# Fuel Cell System for Transportation – 2005 Cost Estimate

## Independent Review October 2006

## INDEPENDENT REVIEW TEAM SUMMARY REPORT

Subject: Independent Review Team Report

**Figure 1: PEM Fuel Cell System Model developed by Argonne National Laboratory (Carlson et al. 2005)**

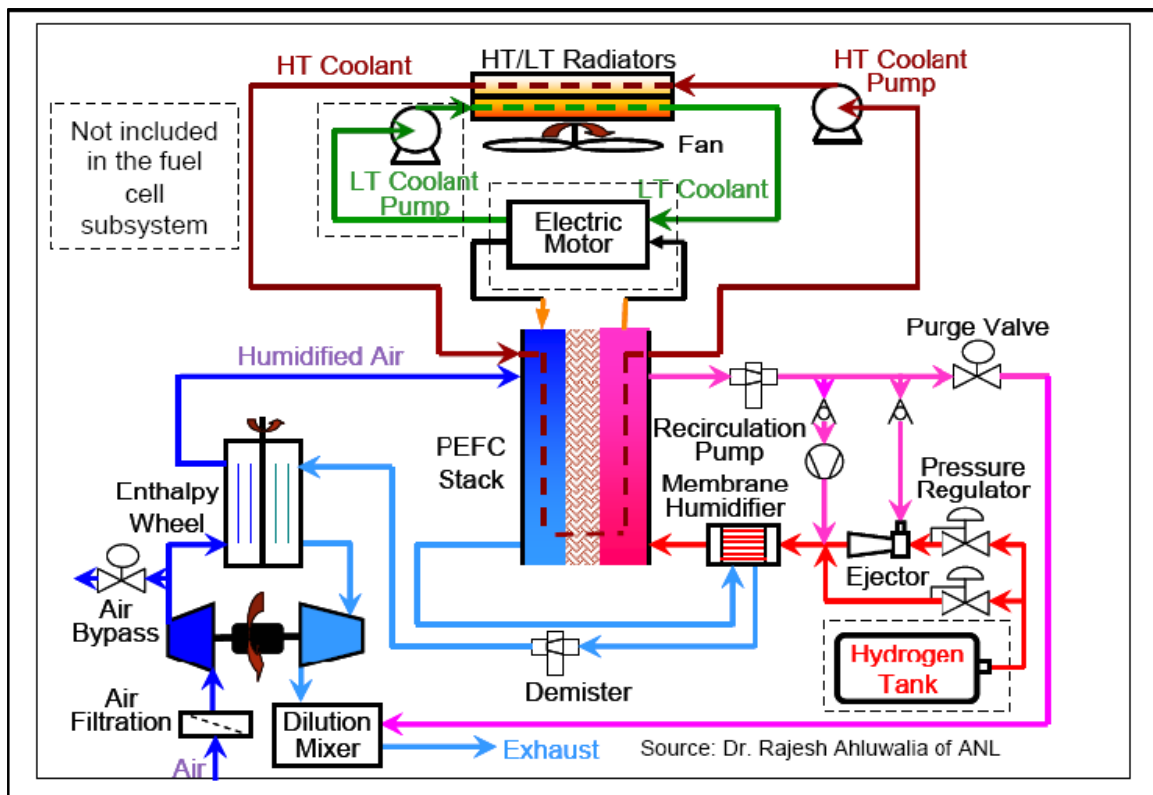
Interviewees believed the BOP costs for the fuel cell power plant were consistent with their understanding; however, they expressed concerns that the specific system or BOP components differed from their experience and that their final power plant designs for commercial production would be different from the ANL model used by TIAX. They also expressed caveats concerning the possible BOP cost increases to accommodate application issues such as:

- Cold start
- Durability – reliability of BOP components with moving parts (enthalpy wheel) and humidification approach
- Operability – transient response, hot day operation, hill climbing, air conditioning.

Some BOP components have not been fully demonstrated. Industry reported to the Team that the compressor-expander was based on data from separate devices and the combined device had not been demonstrated. The enthalpy wheel was considered bulky and its ultimate reliability was questioned. Discussions with industry identified alternative technologies that would replace the compressor-expander and possibly the enthalpy wheel.

Predictably, the ANL model was accepted by some of the fuel cell manufacturers, but not by all. Fuel cell integrators have their own fuel cell system designs based on their proprietary technologies. The configuration of the fuel cell system has a strong influence on the cost analysis, since it will influence the component performance specifications (e.g., inlet and outlet pressures, temperatures, flow-rates, and compositions) and establishes the BOP components. The ANL model may be too focused on one PEM system or one BOP component manufacturer. Industry representatives suggested alternative system designs and recommended that a study be undertaken to identify the optimum system for PEM fuel cells.

The PEM fuel cell system design should be reconsidered. Industry suggested alternative system designs and a study to identify the optimum system for PEM fuel cells. Any future models should be developed with broader industry and national laboratory input.
